**SUBJECT** **Update requested to the Auckland Unitary Plan (Operative in Part 2016) (AUP)**

# **Alteration of a designation under Section 181(3) of the Resource Management Act 1991**

Auckland Council has received a request from Wiri Oil Services Limited under section 181(3) of the Resource Management Act 1991 (RMA), dated 7 November 2025, to alter Designation 9701, Hazardous Substance Terminal, Wiri Oil Services Ltd. It is proposed to increase the height threshold applying to tank T1722 from 20 metres to 24 metres.

**Wiri Oil Terminal – Tank Roof Replacement**

**Figure 3: Proposed Amendment to Designation Diagram 5.11**

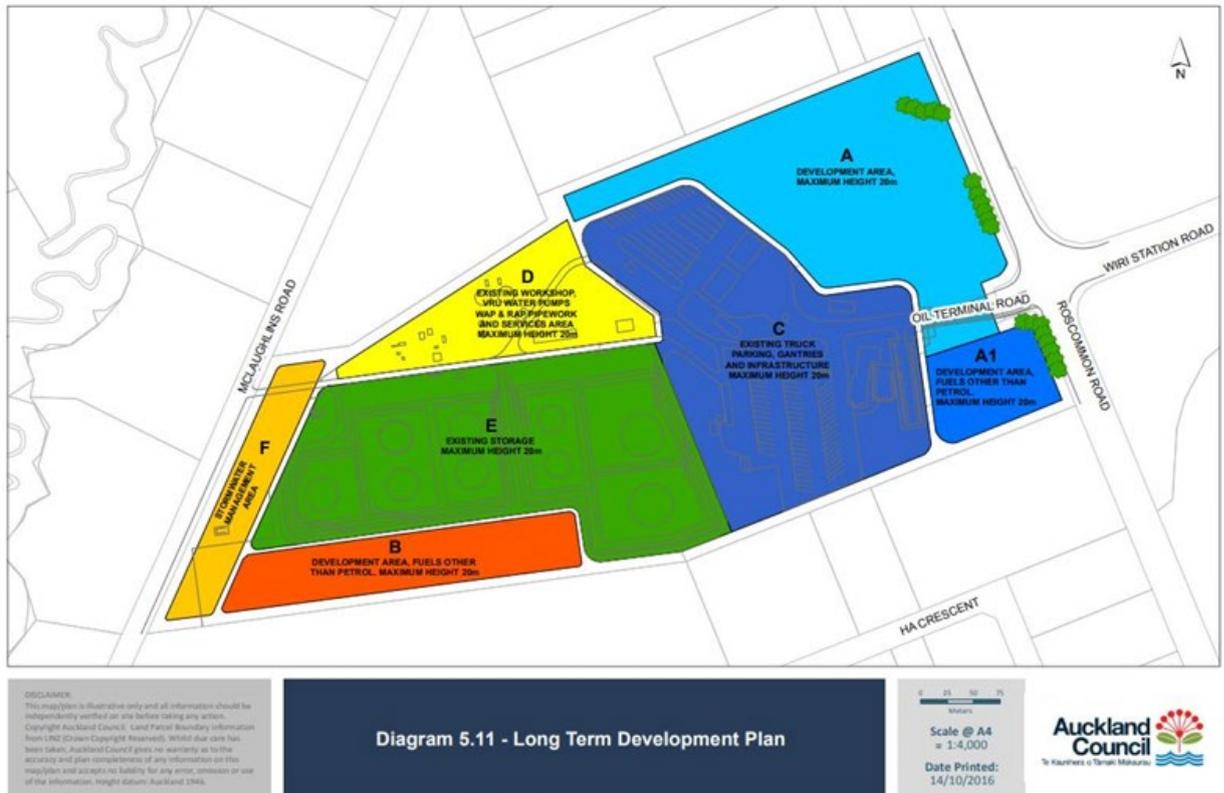
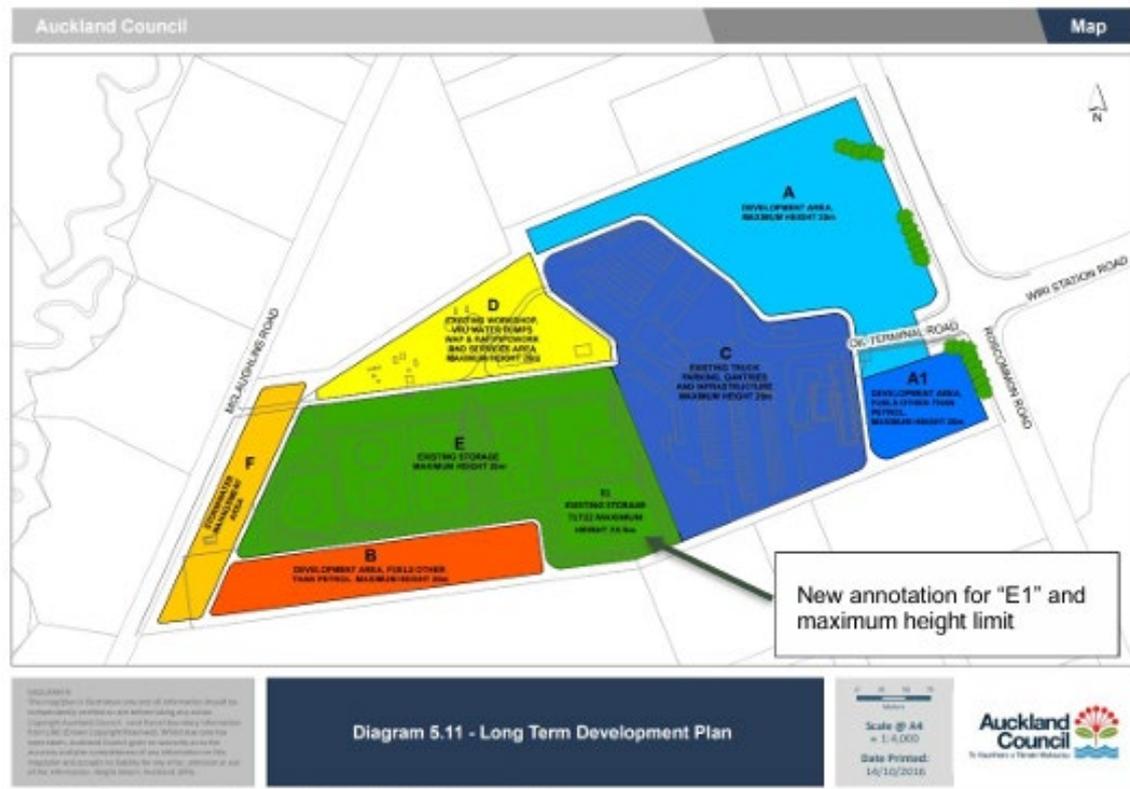
To enable the height of the roof of T1722 to be increased to up to 24 metres WOSL proposes to alter Diagram 5.11, and Condition 1 and Condition 8 – “Height” of Designation 9701.

In respect of Diagram 5.11 it is proposed that Area “E” as shown in Diagram 5.11 is amended to include a sub-zone referred to as “E1”, that will provide for a maximum height of 24m in relation to tank T1722.

**Figure 3: Locality and Elevation plans of proposed Tank 1722 changes**

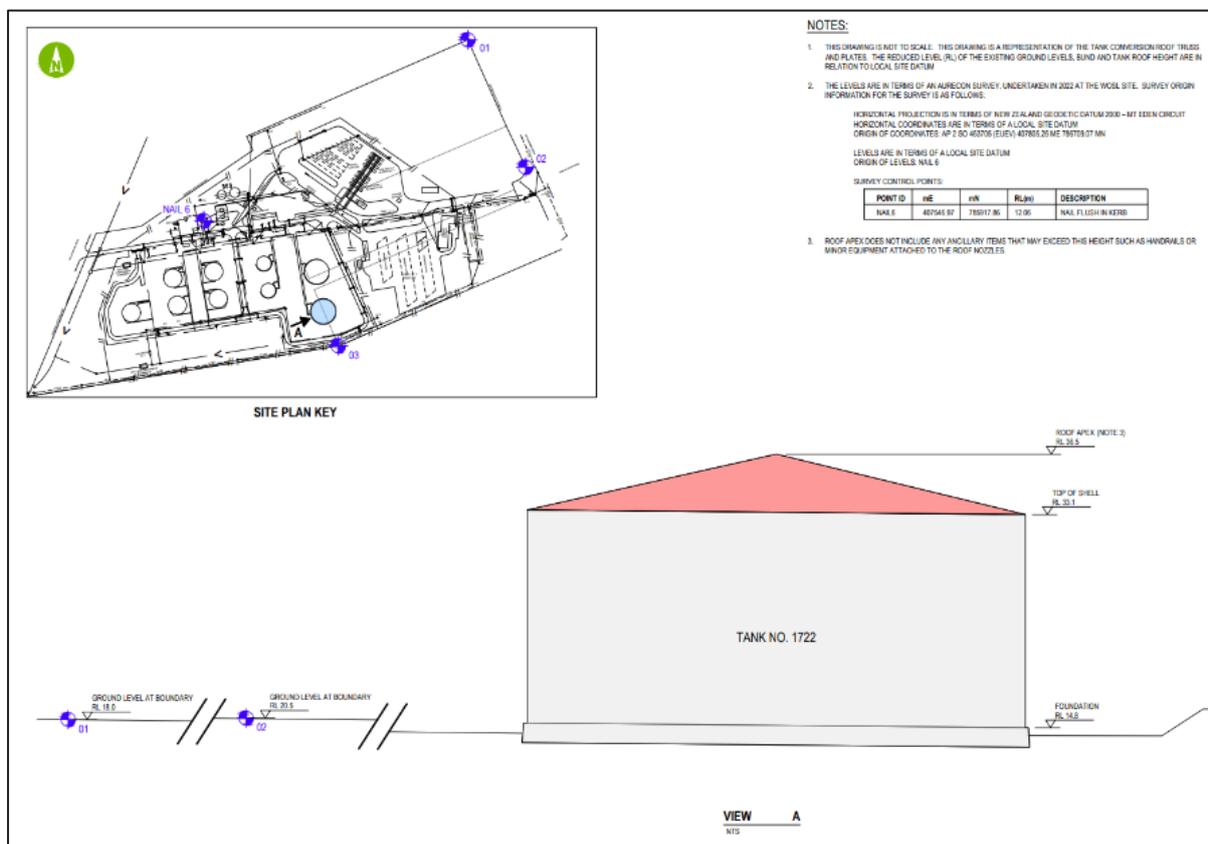
Drawings of the proposal showing the location of tank T1722 on the site and elevation plans are attached as **Appendix C**, and reproduced in **Figure 3** below. While the expected height of the proposed new tank roof is approximately 23.2m, it is proposed to vary Condition 6 of Designation 9701 to provide for an increase in the height of this tank to 24m, on a contingency basis and to take account of different methodologies for measurement of height.

**Figure 3: Proposed Amendment to Designation Diagram 5.11**

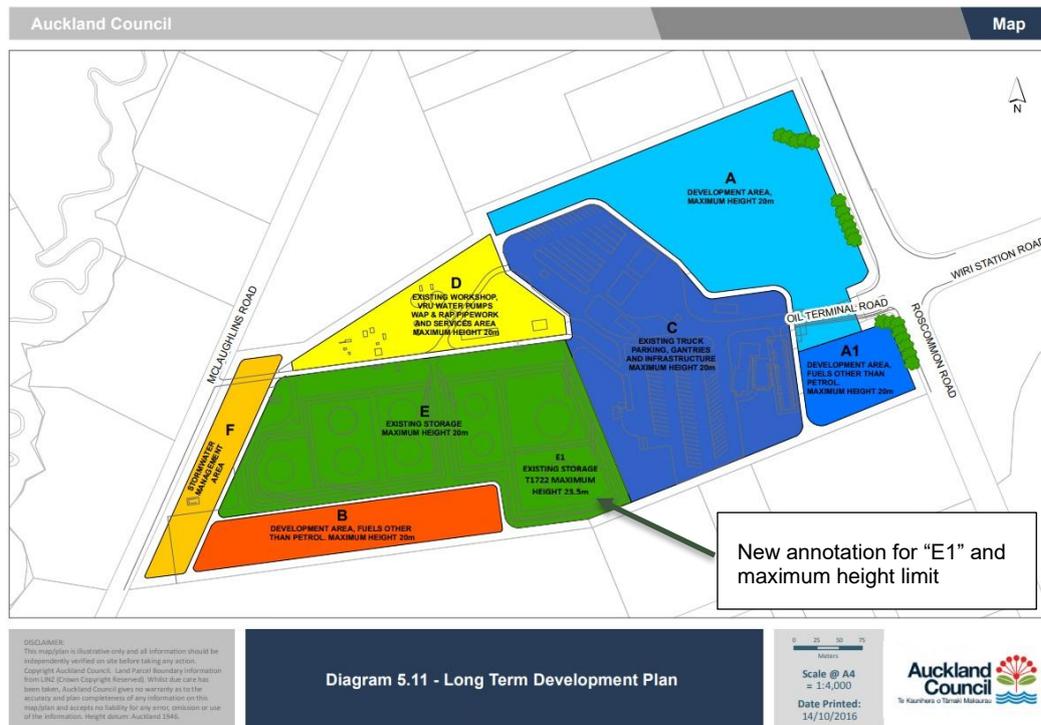
It is proposed that Area “E” as shown in Diagram 5.11 is amended to include a sub-zone referred to as “E1”, that will provide for a maximum height of 24m in relation to tank T1722. This is shown on **Figure 3** below and on the amended version of Diagram 5.11 contained in **Appendix D**.

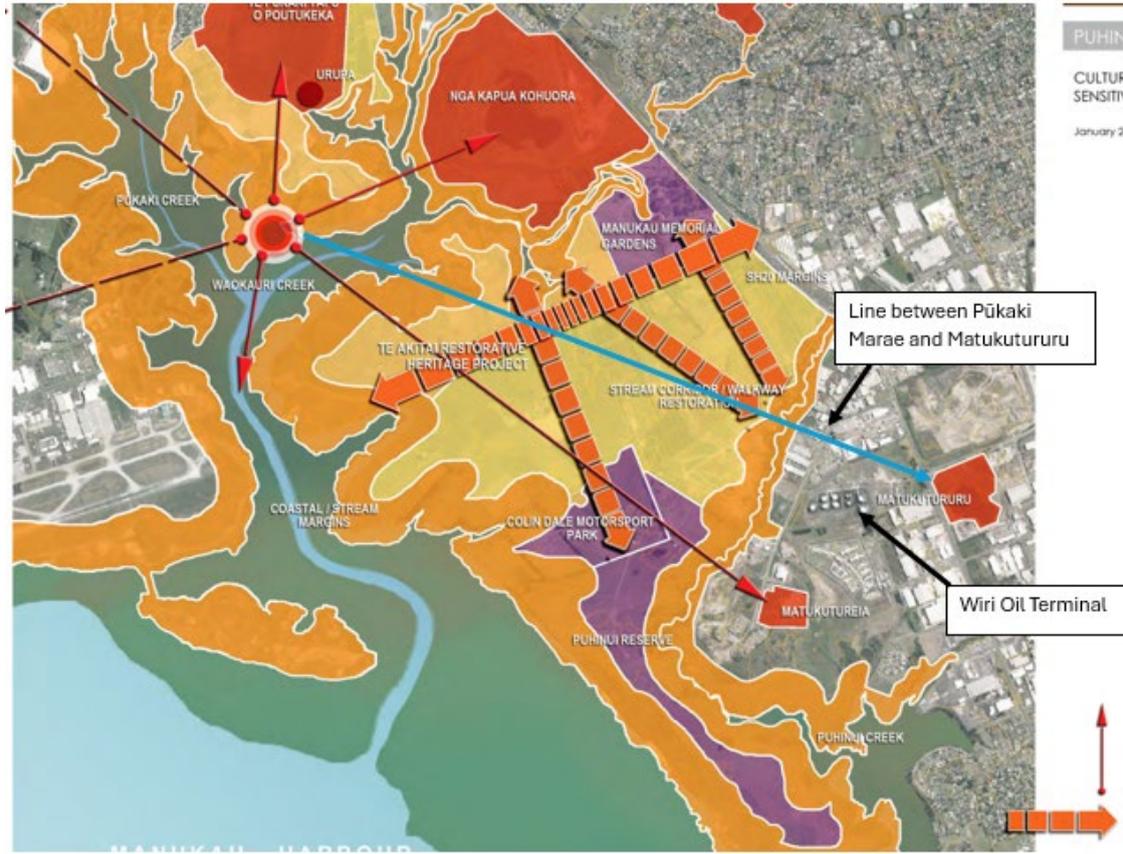
Below, is an excerpt from that mapping, that WOSL has marked up (refer blue line) to show the likely location and alignment of a cultural viewshaft between Pūkaki Marae and Matukutururu, had Matukutururu still been visible, and showing the relationship to the Wiri Oil Terminal site.

We trust this provides sufficient certainty that any adverse cultural effects on Matukutururu as a result of the proposed change in roof form of Tank T1722 will be negligible.
